RE: Heritage Park POADP
File #83-09-57-82 (Revised May 28, 1986)

KB HOME LONE STAR, L.P.		JOB NO.: 00044
HERITAGE PARK		DATE: AUGUST, 2002
MASTER SEWER PLAN		DWN BY: J.L.D.
# 4		CHKD BY: AMQ
		DWG FILE: 00044-SEWER-M
		SHEET NO.
		1 OF 1

HERITAGE PARK

P.O.A.D.P. 3/24/86

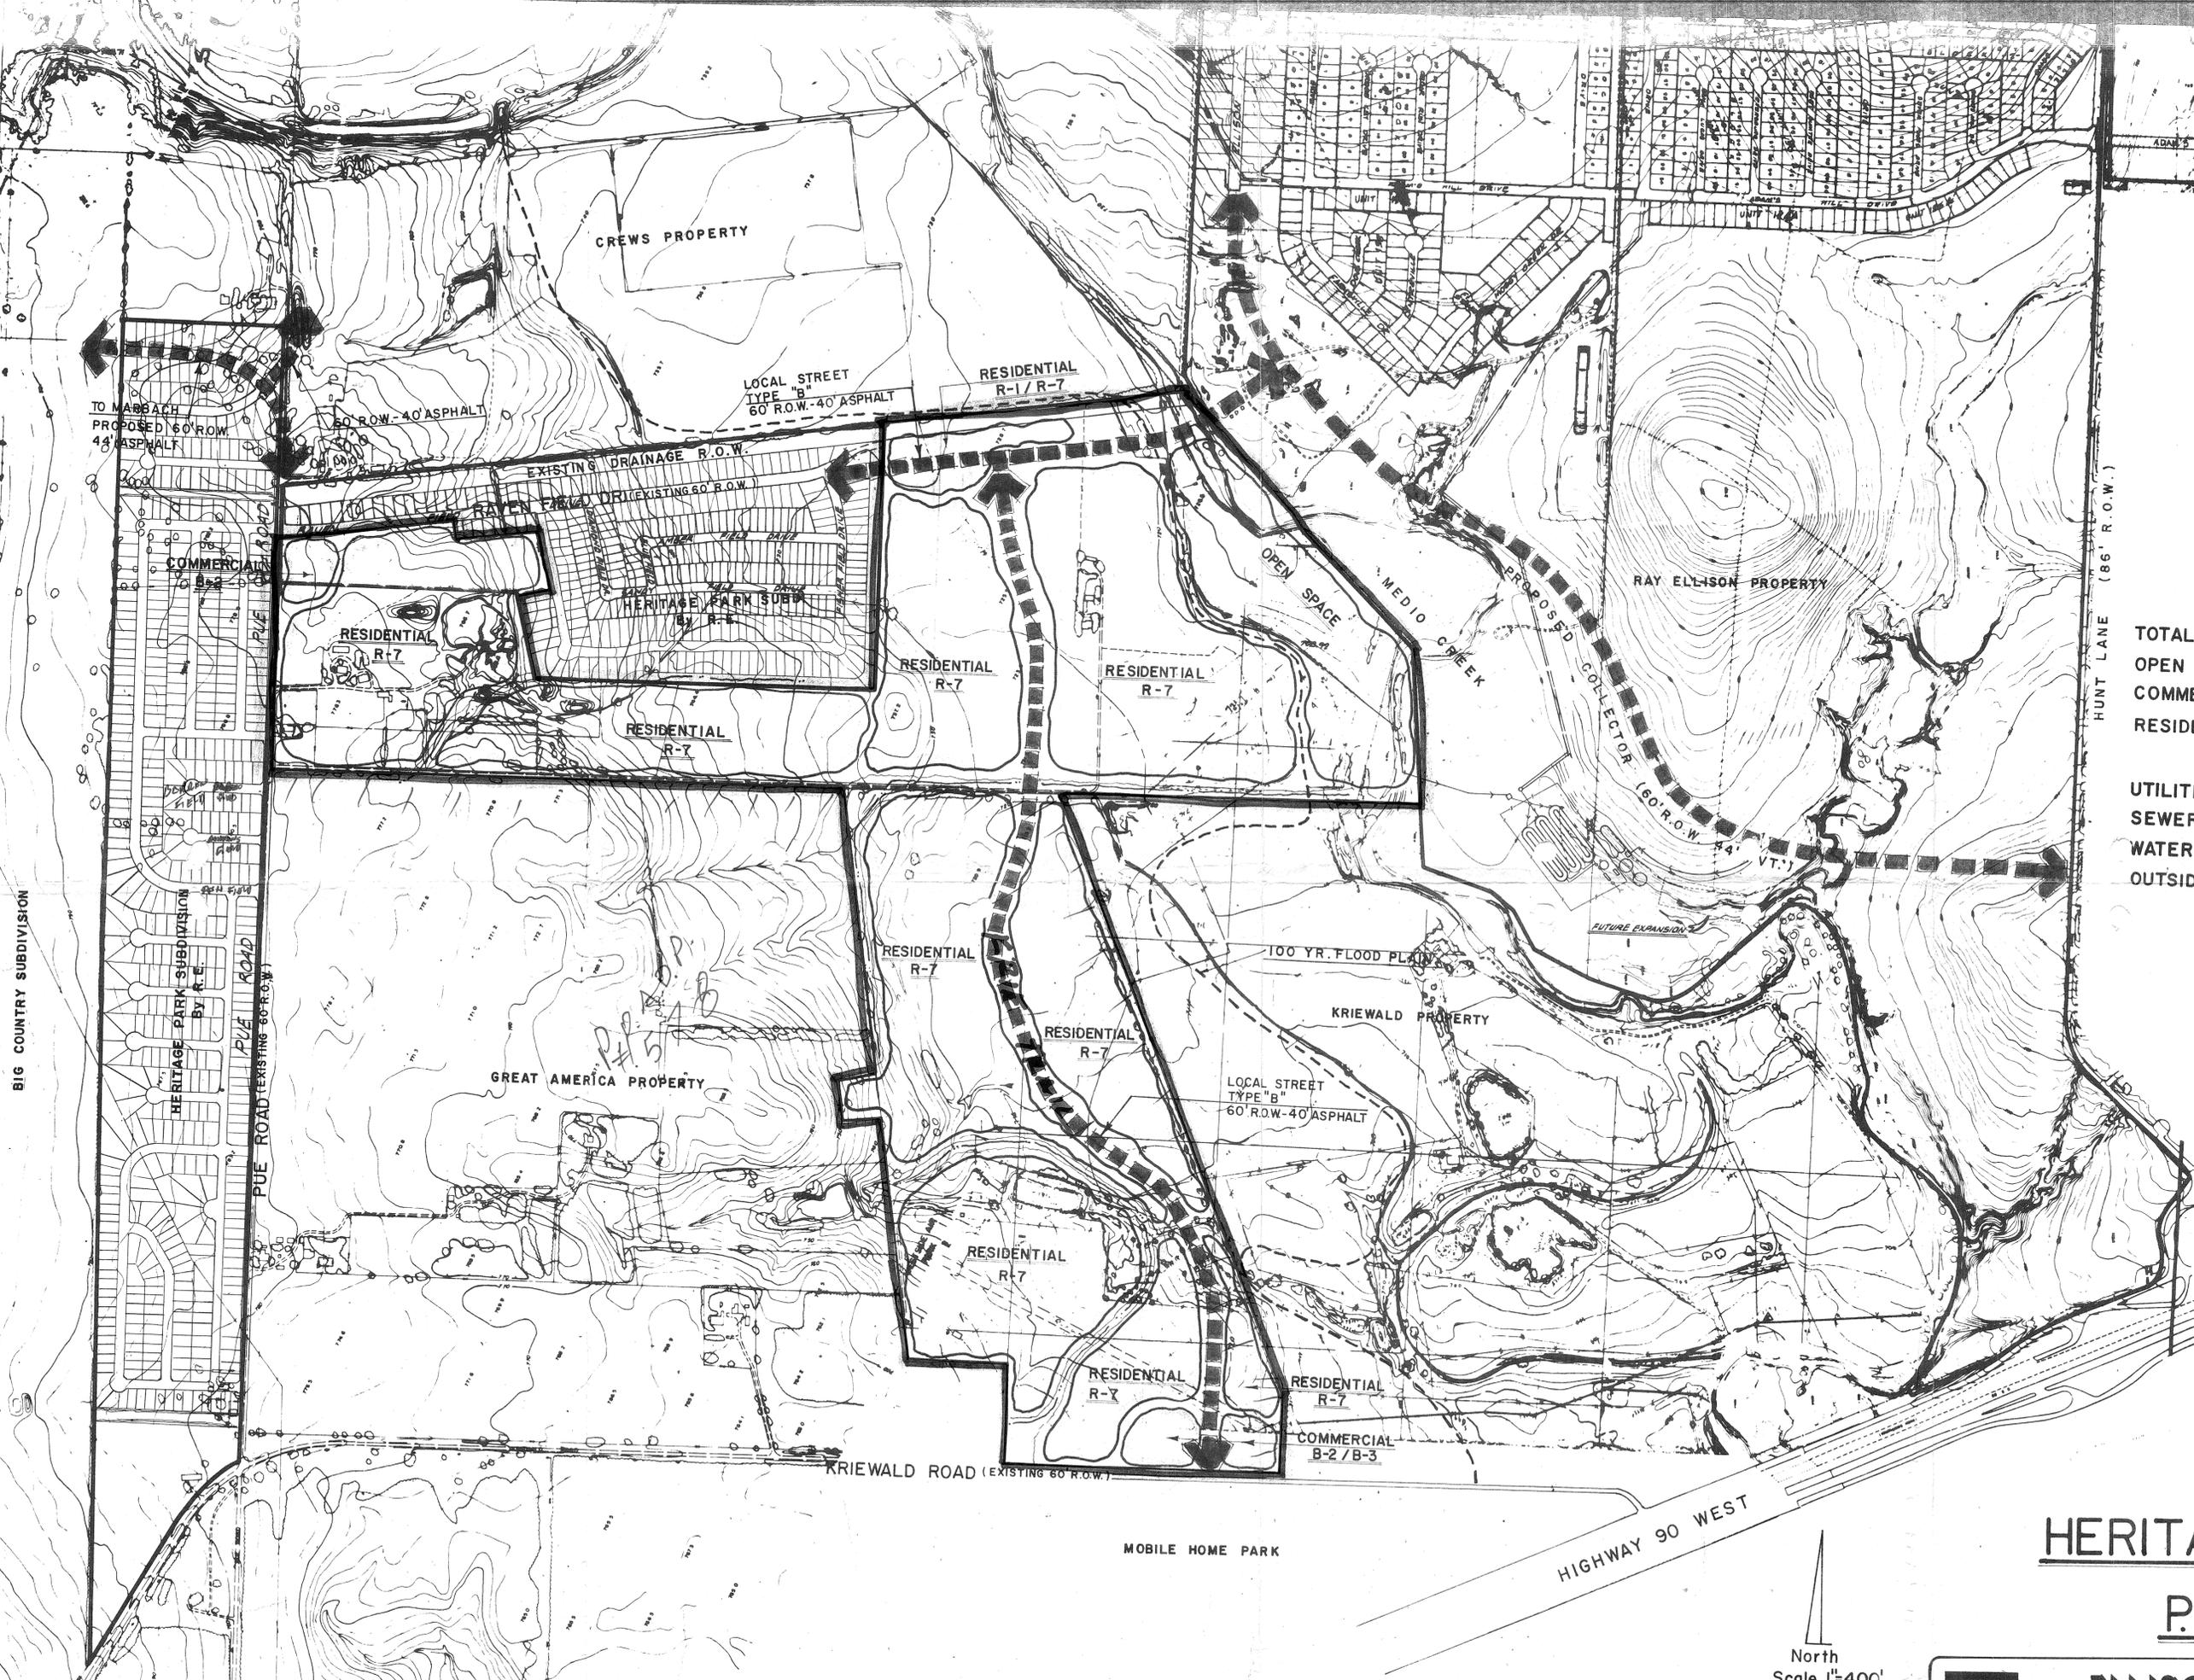
Although a portion of the proposal was reviewed in April of 1983, an important issue addressed in our review has not been resolved. The matter involves the need for stub streets. Attached is a copy of our initial response. According to our records, plats approved in the area do not provide for the stub streets as requested.

However, it is recommended that stub streets be provided to the east and south of the proposed development as provided for by Sec. 36-10(C) of Chapter 36. This would facilitate future development of adjacent properties and preclude any potential landlock situations. In addition, Pue Road appears to be of substandard width. Therefore, consideration should be given to provide the appropriate dedication for future street widening, in order to upgrade it to a standard width in accordance with Chapter 36. Further, as you know, there is pending litigation involving the adjacent property to the north of your proposed development. The issue under litigation is that of the alleged drainage impact on properties in the general vicinity of Heritage Park. It is imperative that careful attention be given to this matter in order to resolve the alleged drainage problem.
